REMARKS

Responsive to the Office Action mailed November 17, 2004, Applicant has studied the Examiner's comments and the cited art. Claims 1-28 are currently pending. In view of the following remarks, Applicant respectfully submits that the application is in condition for allowance.

Drawing Amendments

FIG. 7

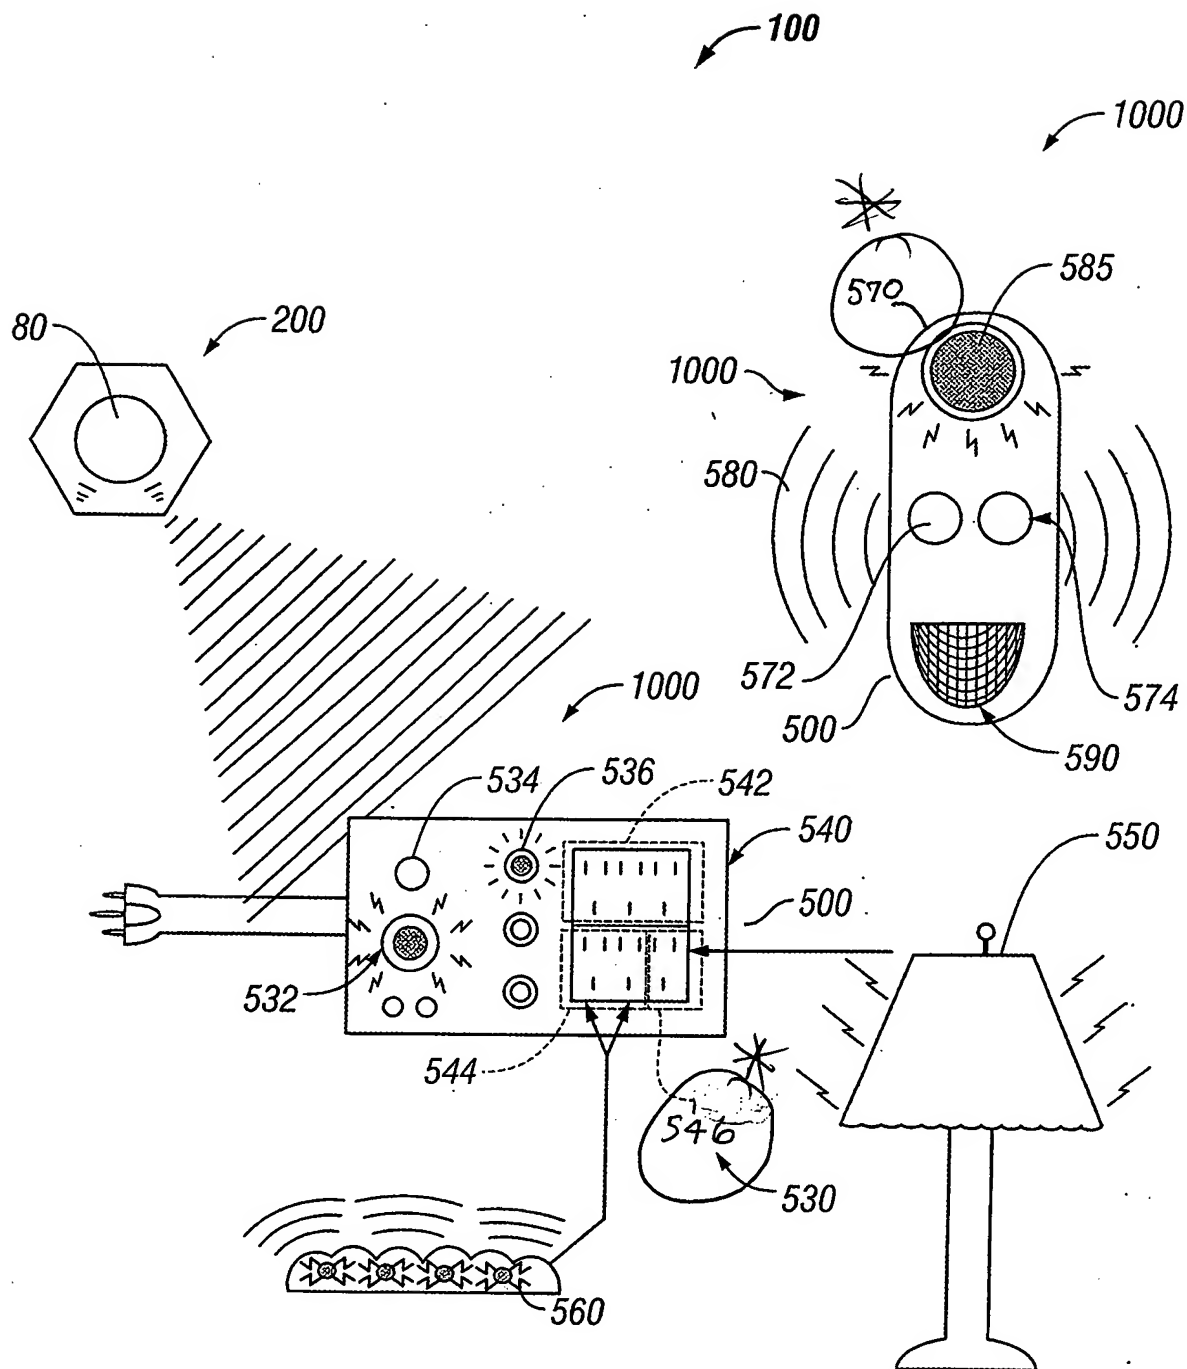
Figure 7 has been amended to make reference to the "blinking oscillating circuit 546" by correcting the reference originally labeled as 916.

Figure 7 has been amended to make reference to the "personal alarm system 570."

FIG. 9

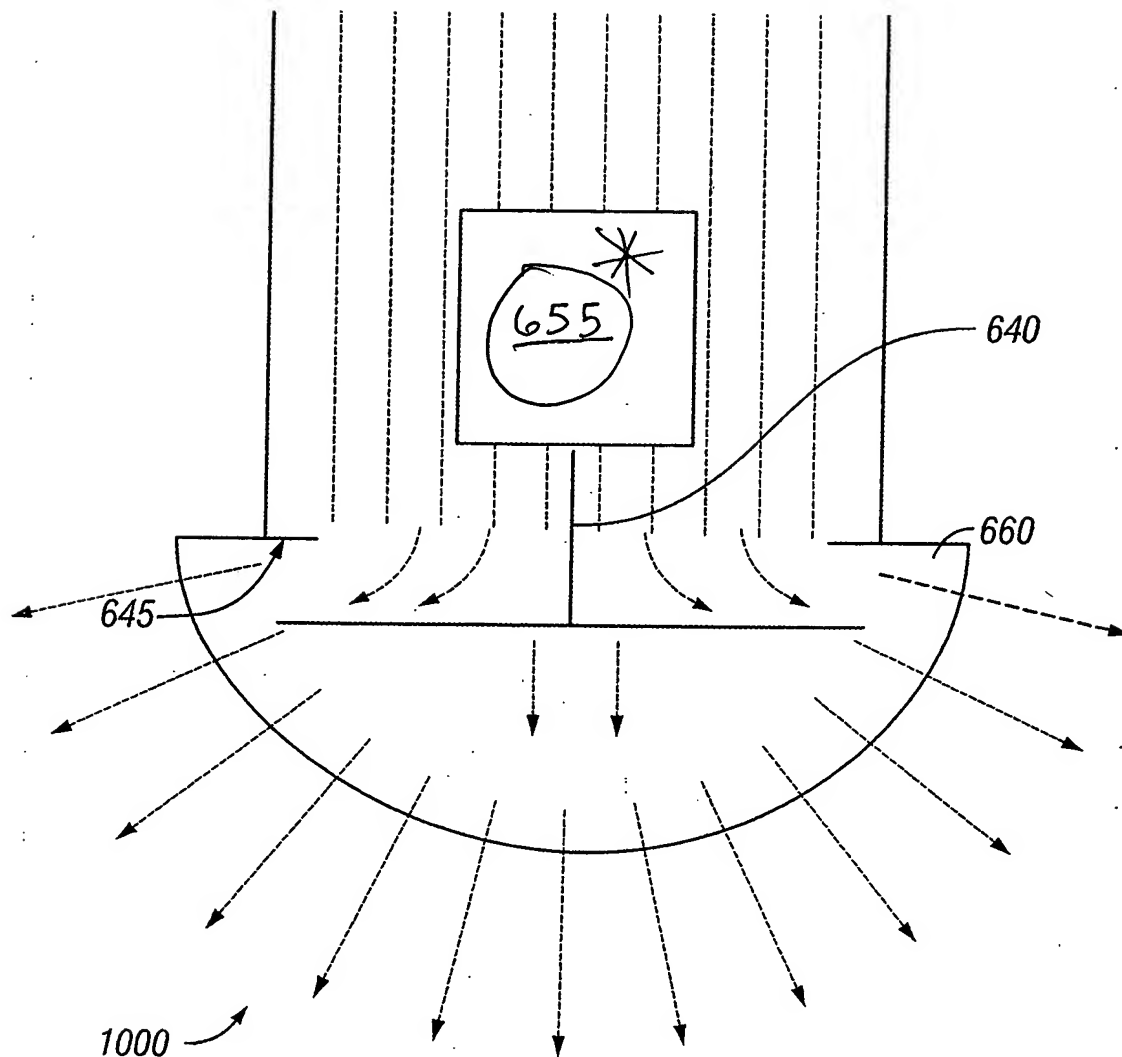
Figure 9 has been amended to make reference to "latch . . . solenoid 655."

FIG. 11

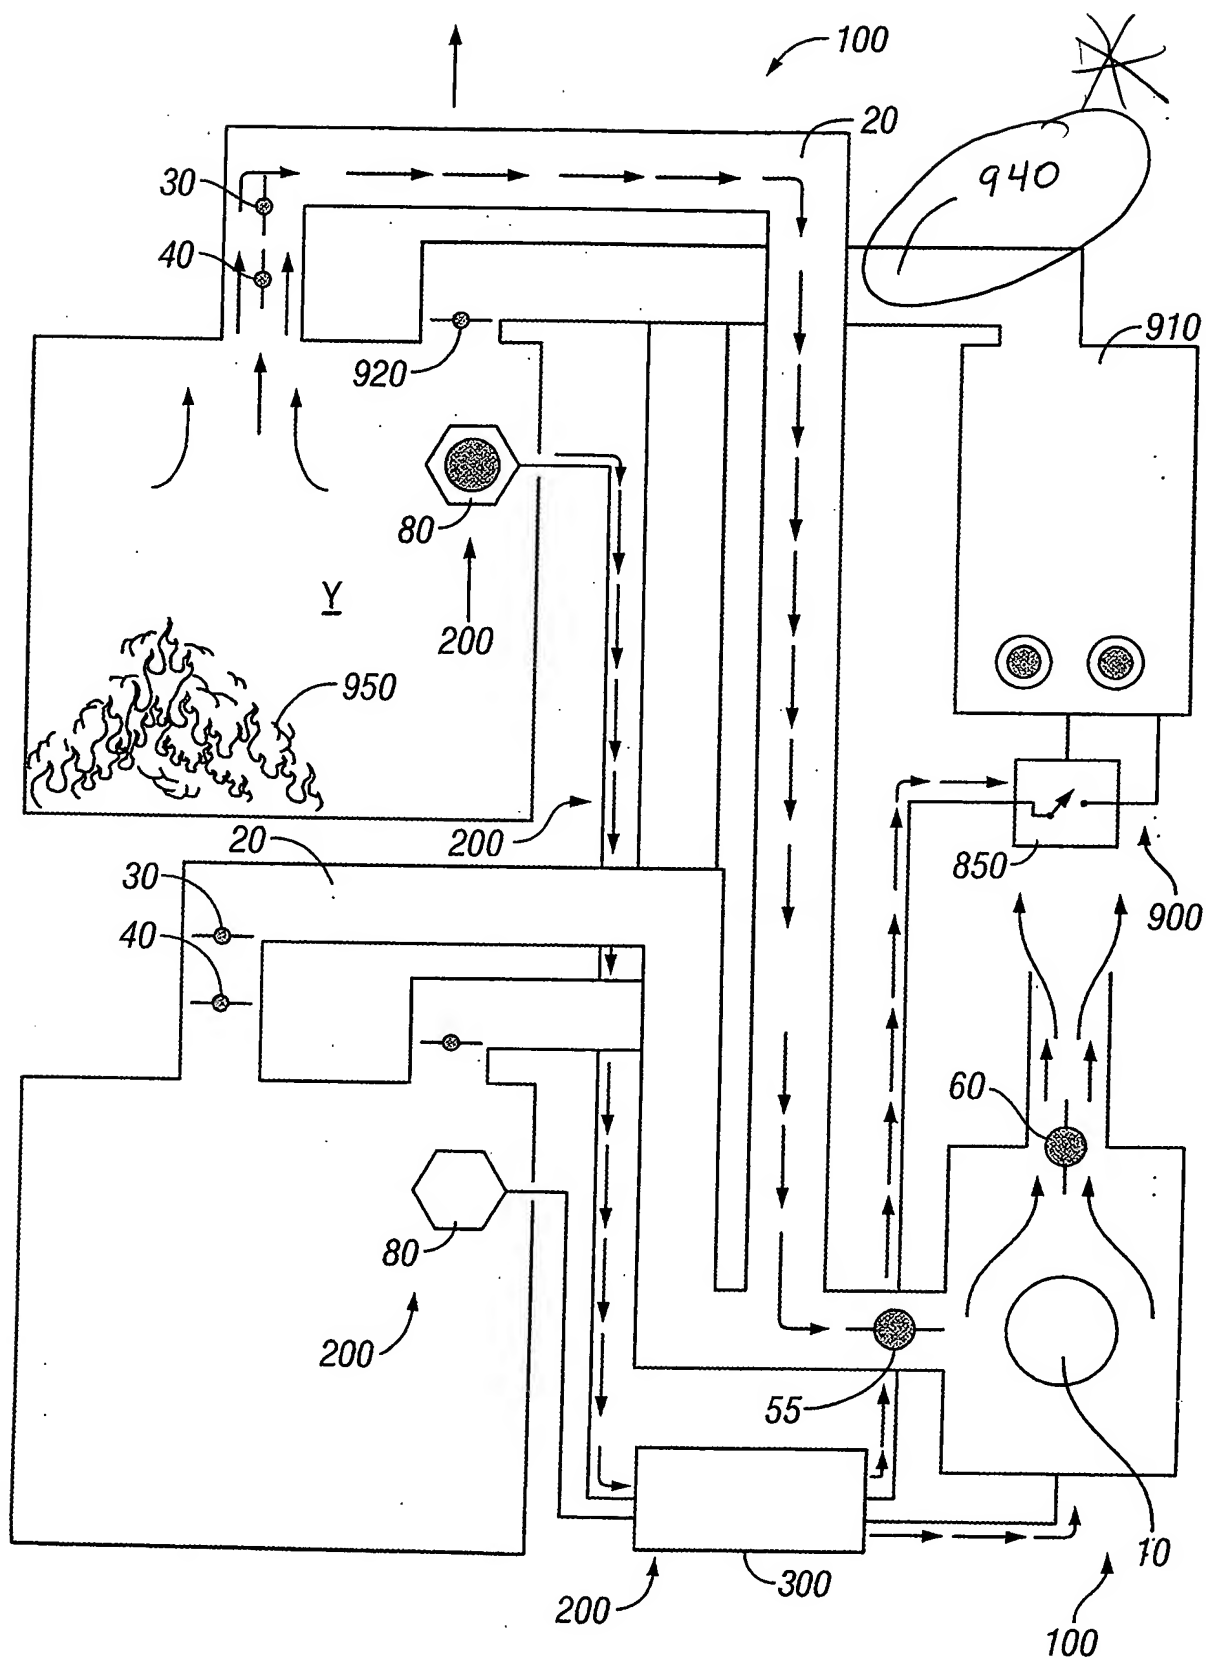
Figure 11 has been amended to make reference to "air conditioning conduit 940."
